## Plan Commission Agenda

City Hall Council Chambers  
203 S. Farwell Street, Eau Claire, WI 54701  
November 18, 2024, 6:00 PM

RE: SP-2414 – Plan Commission Site Plan Review

RE: SP-2415 – Plan Commission Site Plan Review

# NORTHTRAIL AUTO SALES COMMERCIAL RE-DEVELOPMENT CITY OF EAU CLAIRE

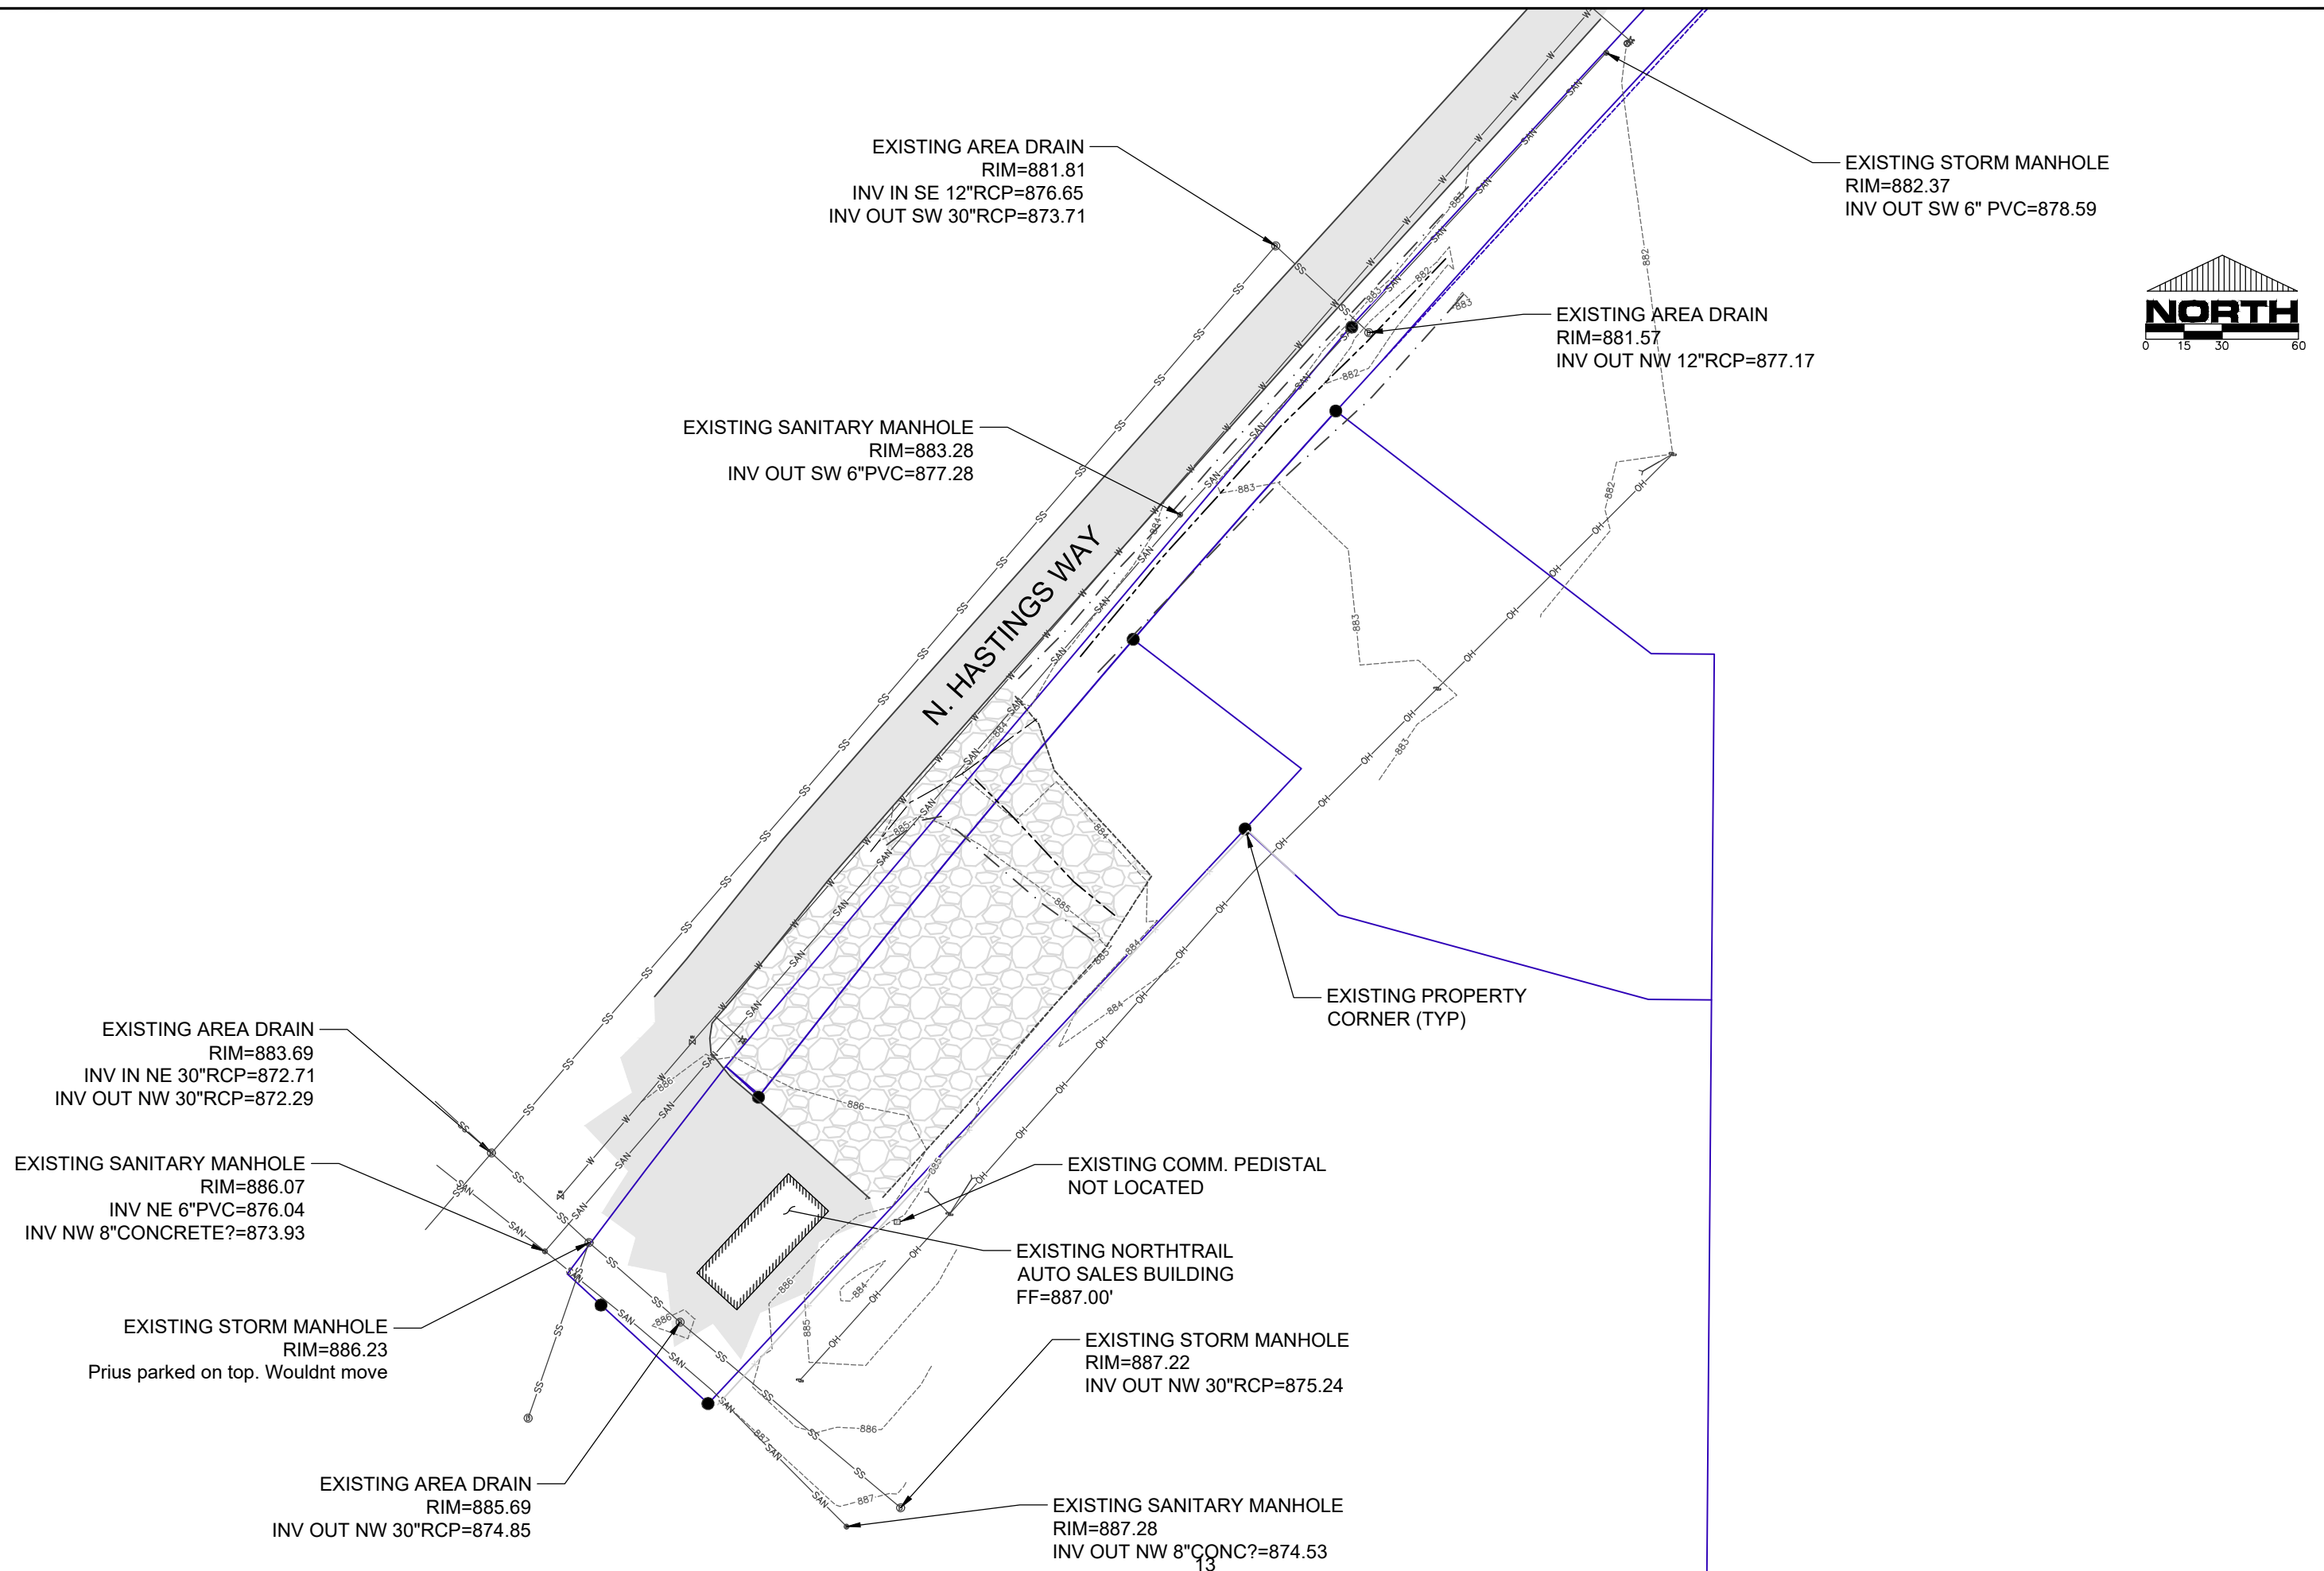
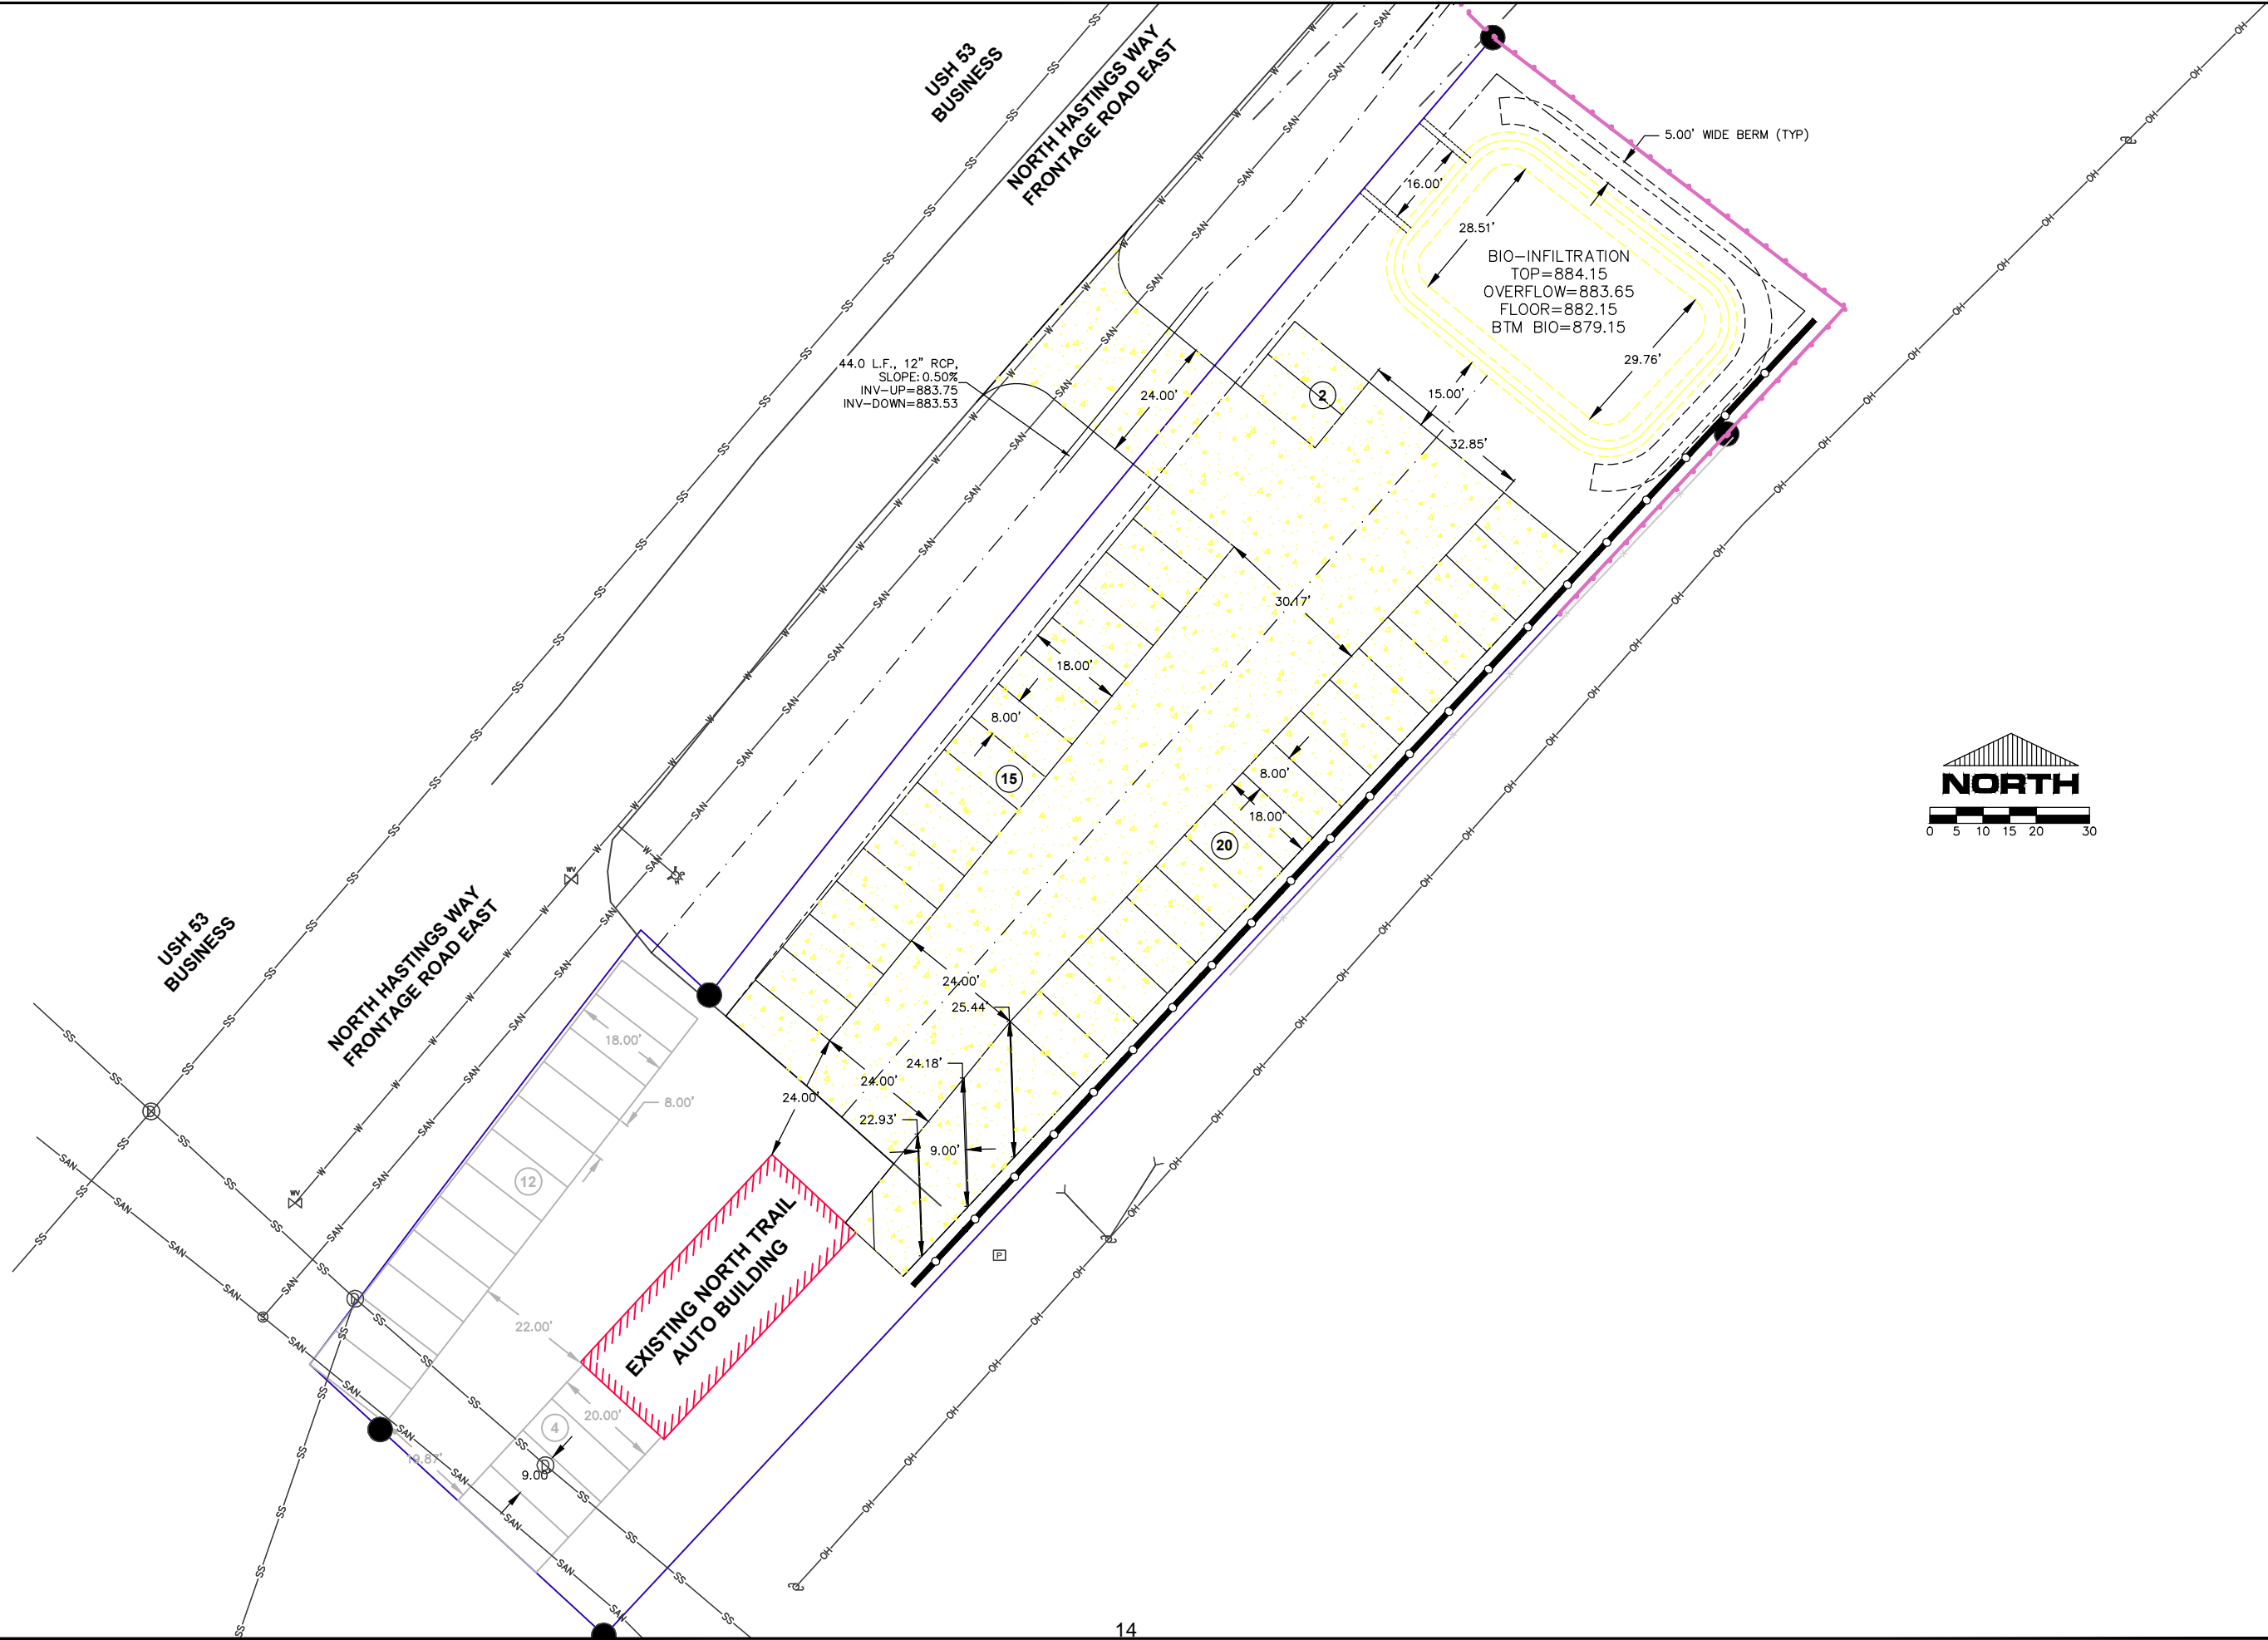
Analysis: Steve and Melissa Hallquist, owners, are requesting the approval of a site plan to expand the parking lot of their vehicle sales business located at 3101 N. Hastings Way. Attached are the narrative and site plan for the project. The proposed site plan for Northtrail Auto Sales shows the parking lot expansion to the northeast. As part of the expansion, the applicant is proposing to pave the existing gravel lot, stripe 37 new stalls, and add a new driveway at the northern section of the property. To compensate for the increase in impervious area, the applicant is proposing a stormwater retention pond on the north side to capture any new runoff.

parking lot screening. Provided in the submitted plan are detailed on the construction of a rain garden in the bioretention pond. As no other landscaping details have been provided, the applicant will need to provide a landscaping plan prior to the paving of the expansion area that contains the following details:

- Street trees at a rate of one (1) tree per 30' lineal feet of the lot frontage for the expansion.
- Plant a row of shrubs, switch grass or equivalent type at a rate of one (1) plug per two feet along the outdoor parking lot.
- An alternative design approach that incorporates a mix of both of the above to meet the intent of the ordinance, while allowing the outdoor display parking area to be seen.

Under Section 18.25.080 C, parking lots require structurally sound abutments, such as curbing or car stops, around their perimeter. Included on the site plan is fence along the eastern property line that serves as a "stop" for vehicles. To cover the rest of the site (including the existing sales area to the south that abuts the frontage road), staff recommends stops or continuous curbing along N. Hastings Way, but not along the northern end. Due to the slope of the site, staff does not recommend requiring curbing along northern line to allow for stormwater to flow into the water retention pond. If the applicant is proposing new lighting, the applicant should provide a plan prior to installation.

The Plan Commission, at its November 18, 2024 meeting, reviewed the above-referenced site plan. Conditions to be shown/satisfied on a revised site plan:

1. The parking lot should be paved by the middle of June, 2025.
2. Street trees should be installed along the expansion area at a rate of one (1) tree per 30', clumps of switch grass should be planted at a rate of 1 clump per 2' of the parking lot, or a mix of both.
3. Vehicle stops, should be provided along the side of the parking lot abutting N. Hastings Way, this can be in the form of "car stops" or continuous curbing.
4. A lighting plan shall be provided that meets the standards of the ordinance.
